Lee Nuclear Station Response to Request for Additional Information (RAI)

RAI Letter Dated: June 22, 2010

**Reference NRC RAI Numbers: ER RAI 157, ER RAI 161, ER RAI 163, ER RAI 165,
ER RAI 167, ER RAI 168, ER RAI 170; Ecology -
Terrestrial**

Revised Figure 4.1-2

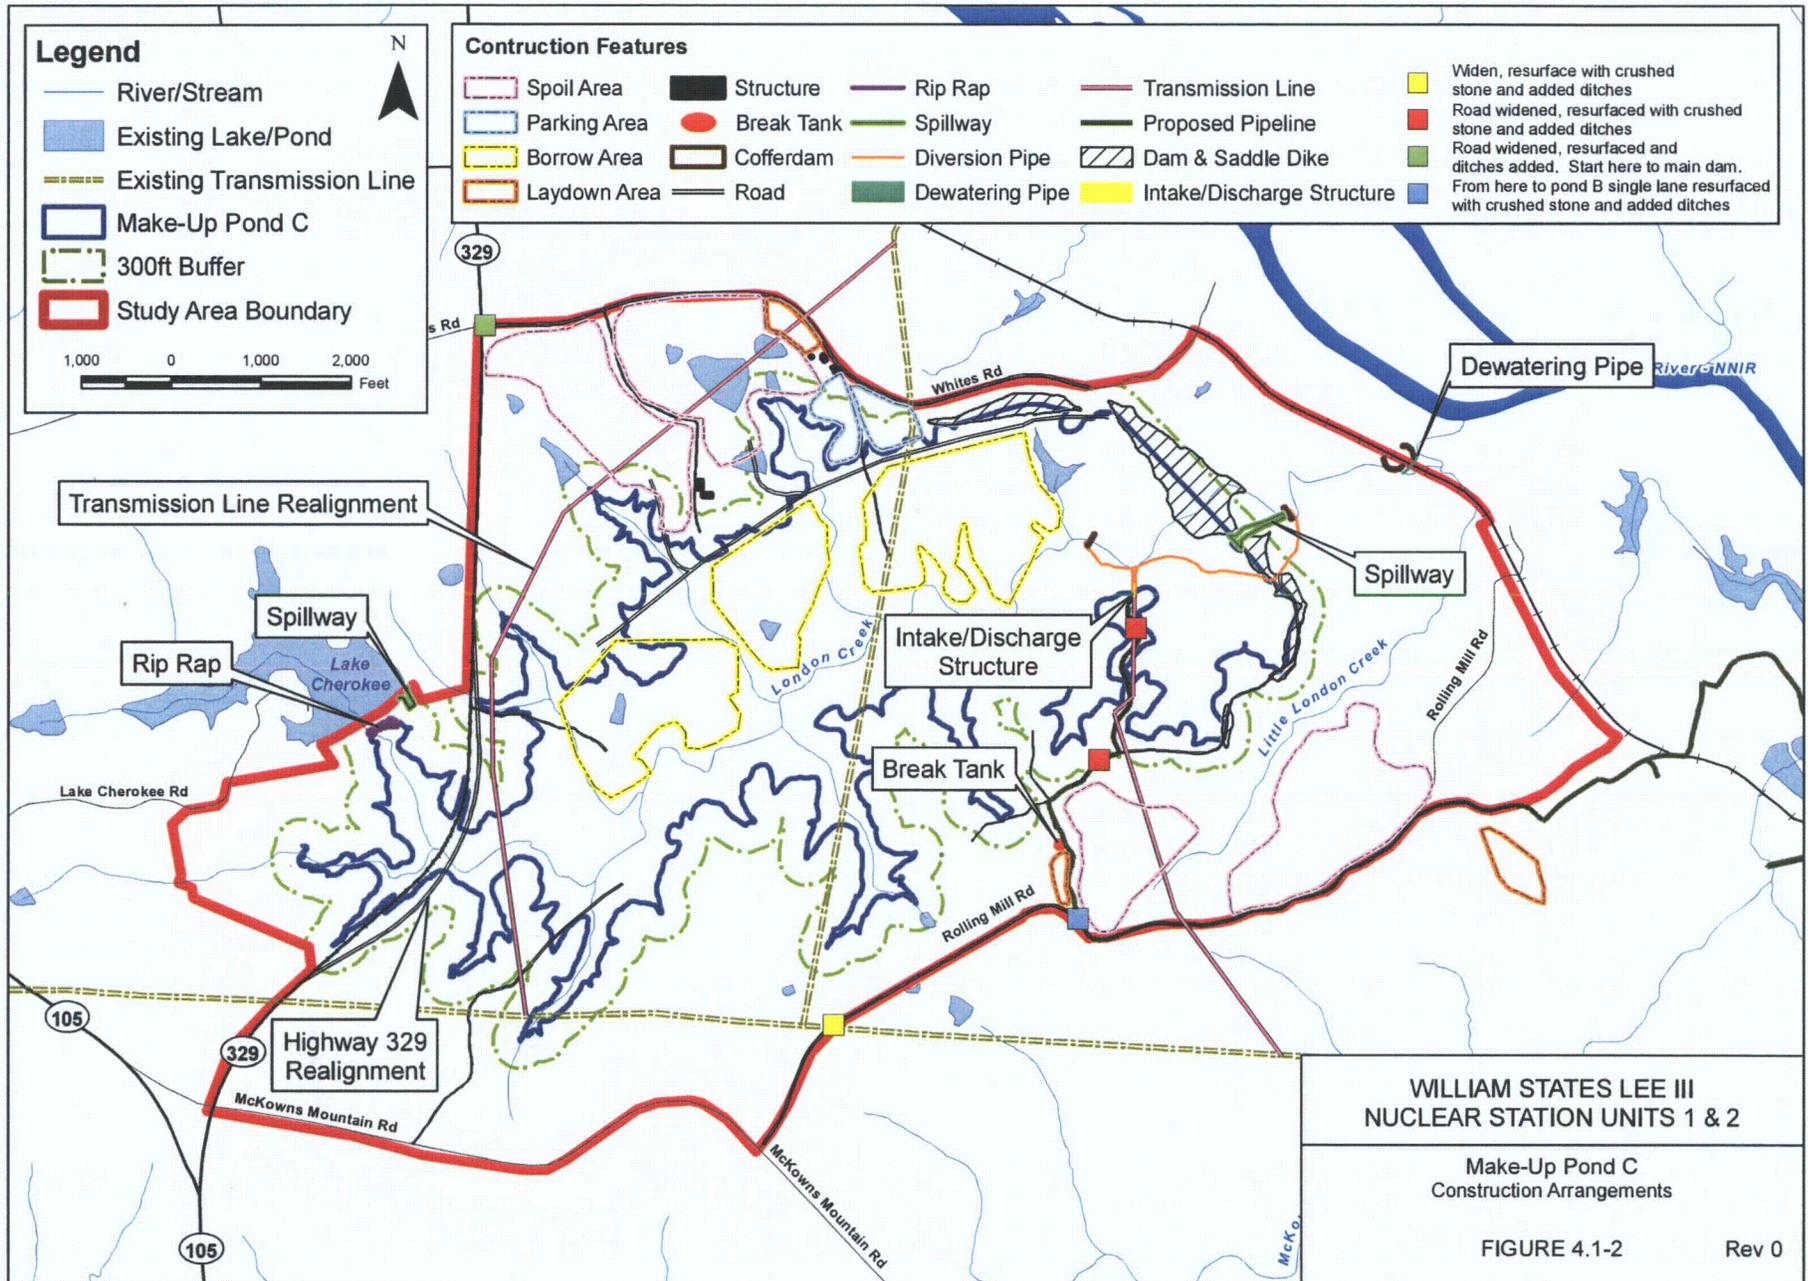
Provide information regarding the location of the proposed new transmission line, its length, corridor width, cover/habitat types it intersects, etc. Provide a graphic depiction of the location of the new transmission line corridor.

The new 44-kV transmission line begins at the intake/discharge structure for Make-Up Pond C and connects to the existing 44-kV line within the Lee Nuclear Site (see attached revised Figure 4.1-2, Attachment 157-02). This transmission line corridor is approximately 5,700 feet long and is 100 feet wide. Land cover types within the transmission corridor are provided within revised Table 4.3-2. Associated revisions to the text in the ER Supplement are provided in Attachment 157-05.

Attachment 157-03
Revised Figure 4.3-3

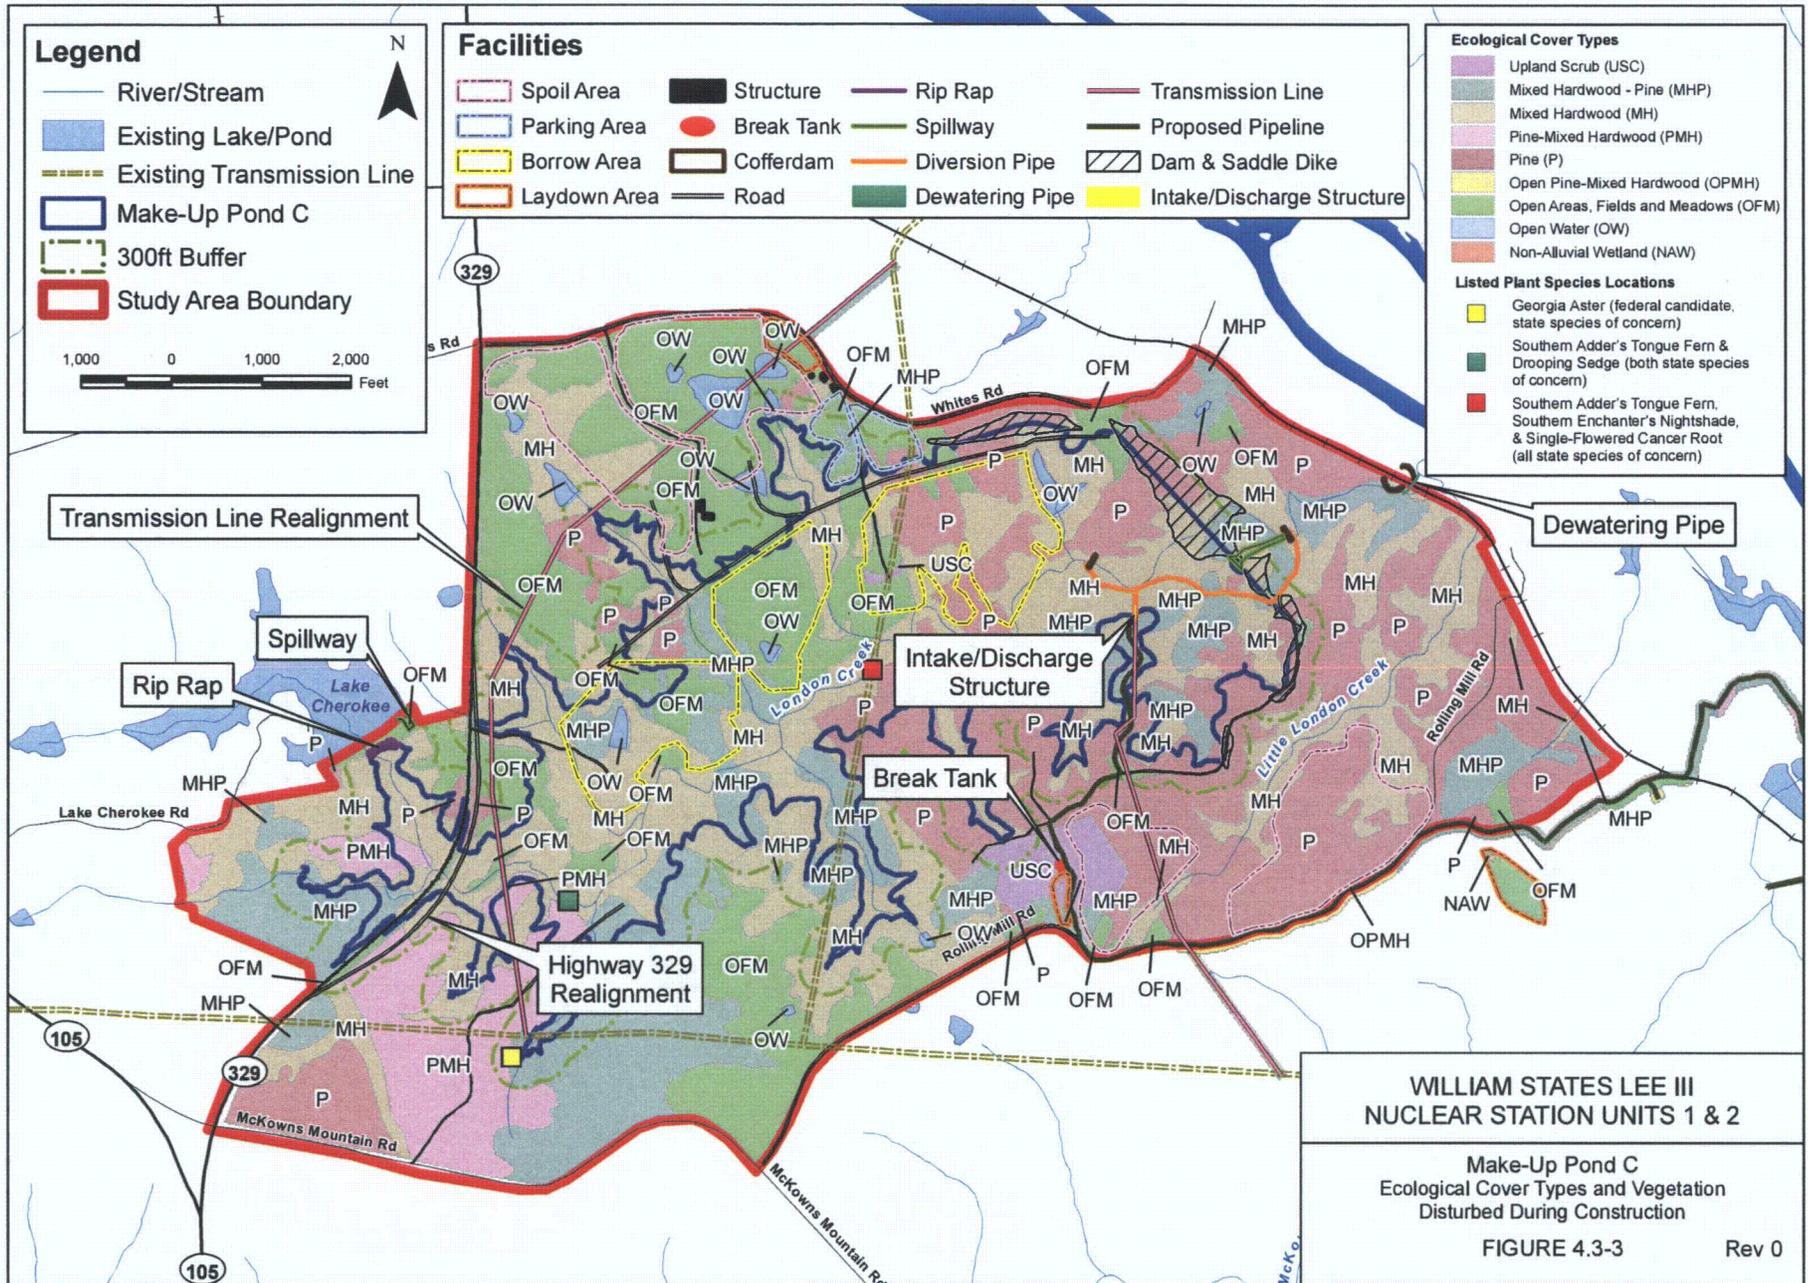
Revise Table 4.3-2 so that the data are grouped into the following three categories: (1) within the inundation area, (2) outside the inundation area but within the study area boundary, and (3) outside the study area boundary.

Revise Table 4.3-2 to include separate quantified impacts for temporary disturbances and permanent habitat losses. Discuss any measures that would be undertaken to restore temporarily disturbed habitats.

Figure 4.3-3 of the ER Supplement has been revised (Attachment 157-03) to show impacts to cover types included in the revised Table 4.3-2. The raw water pipeline within the Lee Nuclear Site extends outside of the figure, however, it is depicted on Figure 4.3-1 in the ER Supplement. This figure has not been revised, but is included as an attachment for reference (Attachment 157-04). As clarification wetlands were mapped as a separate cover type within the Lee Nuclear Site but not within the Make-Up Pond C study area. The jurisdictional status and extent of wetlands shown on Figure 4.3-1 are subject to verification by the U.S. Army Corps of Engineers. An updated discussion concerning wetland impacts from Make-Up Pond C construction features located outside Make-Up Pond C is provided in response to RAI 164.

Figure 4.3-1

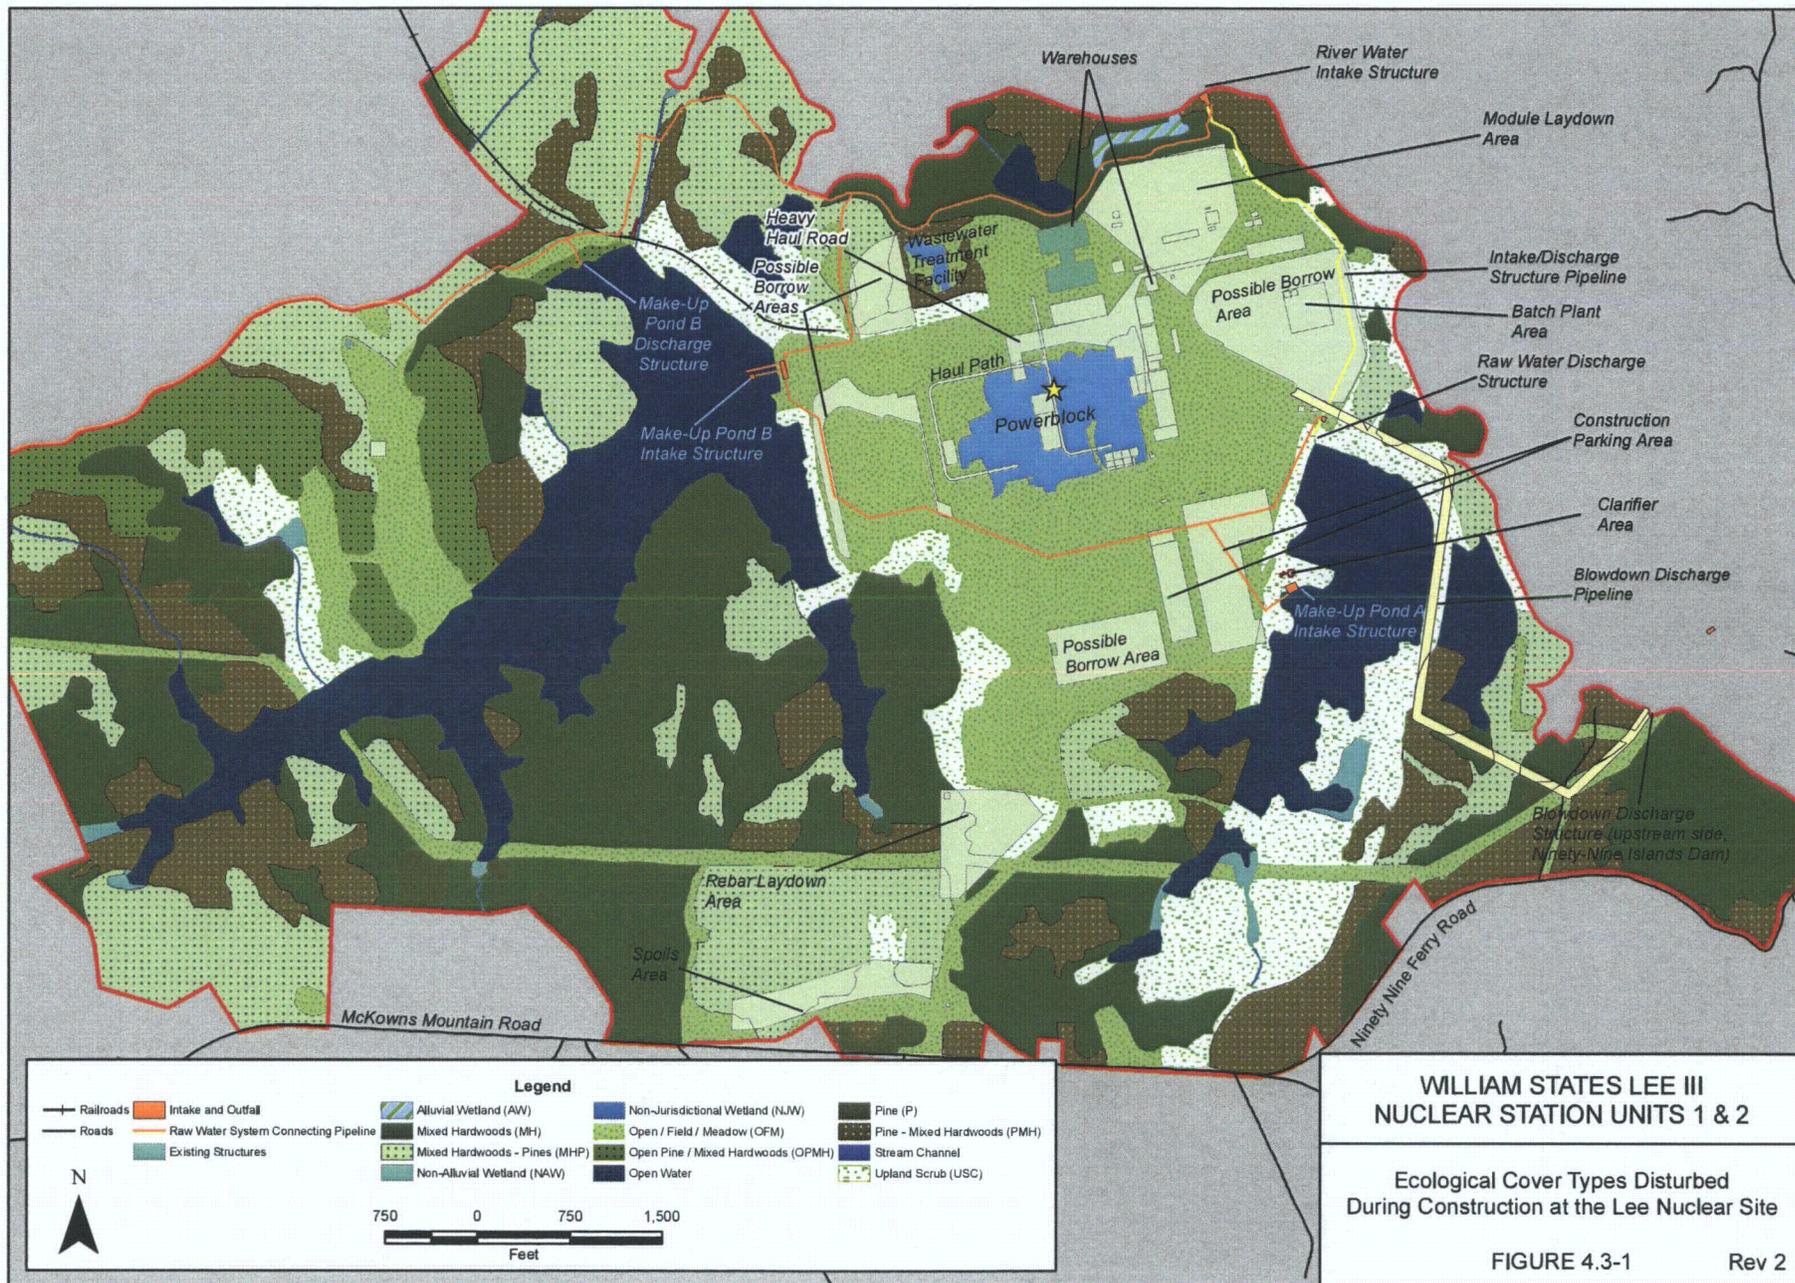
Provide acreage data on vegetation cover types in the portions of the re-routed transmission line and pipeline corridors which occur outside the study area, and the laydown area that occurs outside the study area.

Vegetation cover types within the Make-Up Pond C associated facilities outside of the Make-Up Pond C study area, including the re-routed transmission line, the raw water pipeline, and the laydown area, are provided in revised Table 4.3-2 (Attachment 157-01). Since all vegetation cover within the aforementioned areas is assumed to be impacted during construction, the acreage of vegetation cover within these areas is equal to the acreage to be impacted in Table 4.3-2.
